Traffic Response Report

MIXED USE DEVELOPMENT

28 FISHER RD / 9 FRANCIS ST, DEE WHY, NSW

MARCH, 2023

Upper Basement:

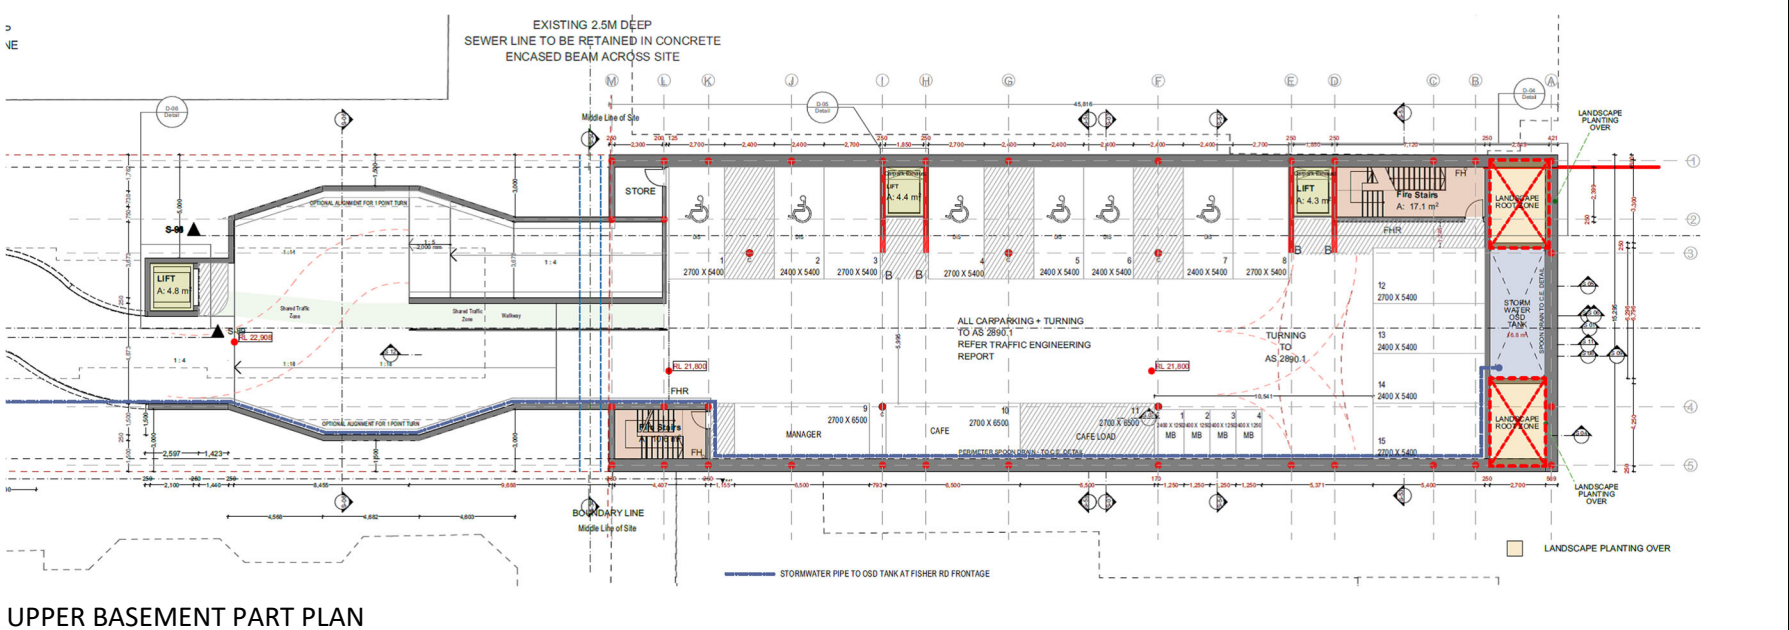
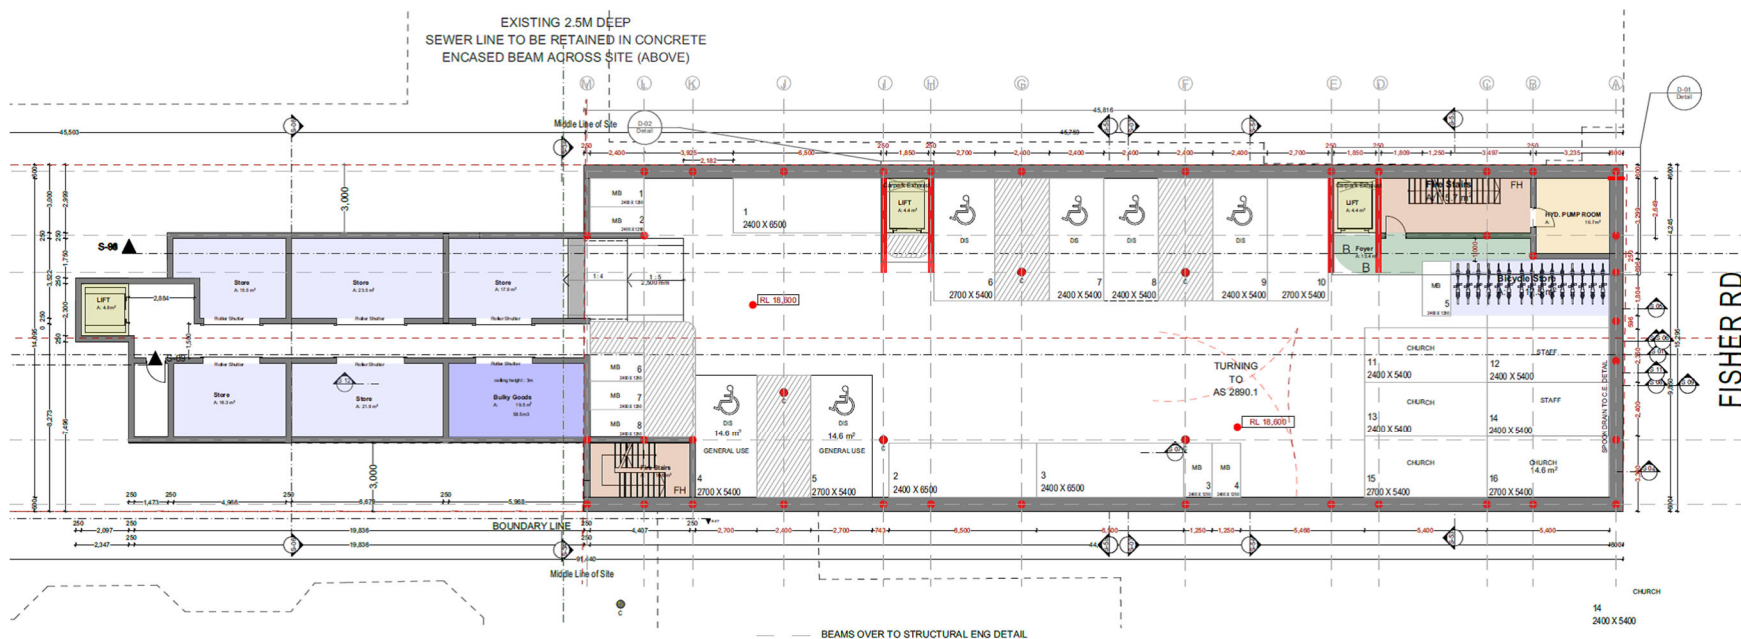
DSAP suggested more room and wider turning circle could occur at the head of the basement ramps to allow for better turning. This meant closer side boundary setbacks to 1500 and the lower vehicle ramps moved slightly to accommodate

Refer to the submitted Amended Architectural Drawings set

Structural engineering support zones were better defined with the consultant and hence carparking layers were replicated on both levels to better allow weight bearing through the structure

More defined storage and bulky goods store areas were requested and incorporated.

These things led to minor parking amendments.
Refer to the submitted Amended Architectural Drawings set

LEVEL 1 FRANCIS ST PART PLAN

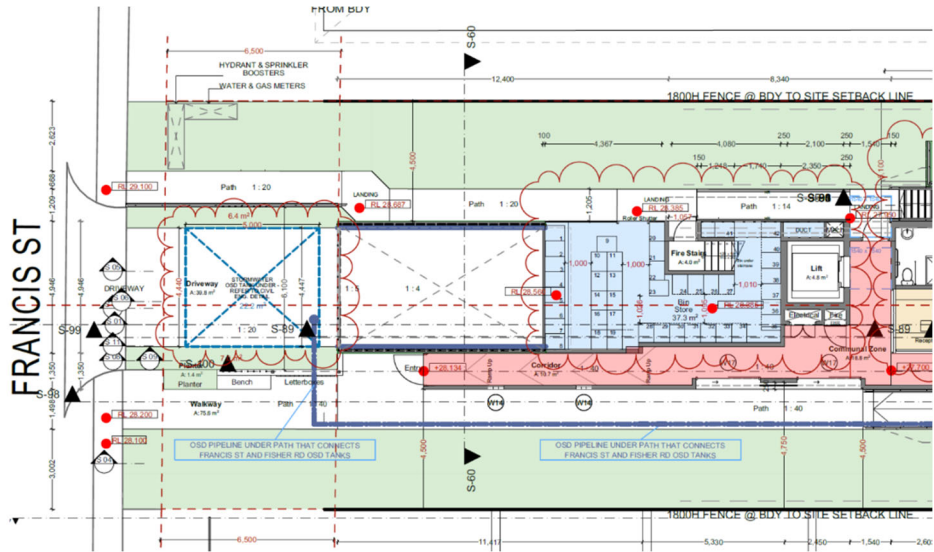
Less concrete driveway appearance was requested at the Francis St Frontage and hence porous paving and low trafficable planting was incorporated into the entry driveway sides

Refer to the submitted Amended Architectural Drawings set
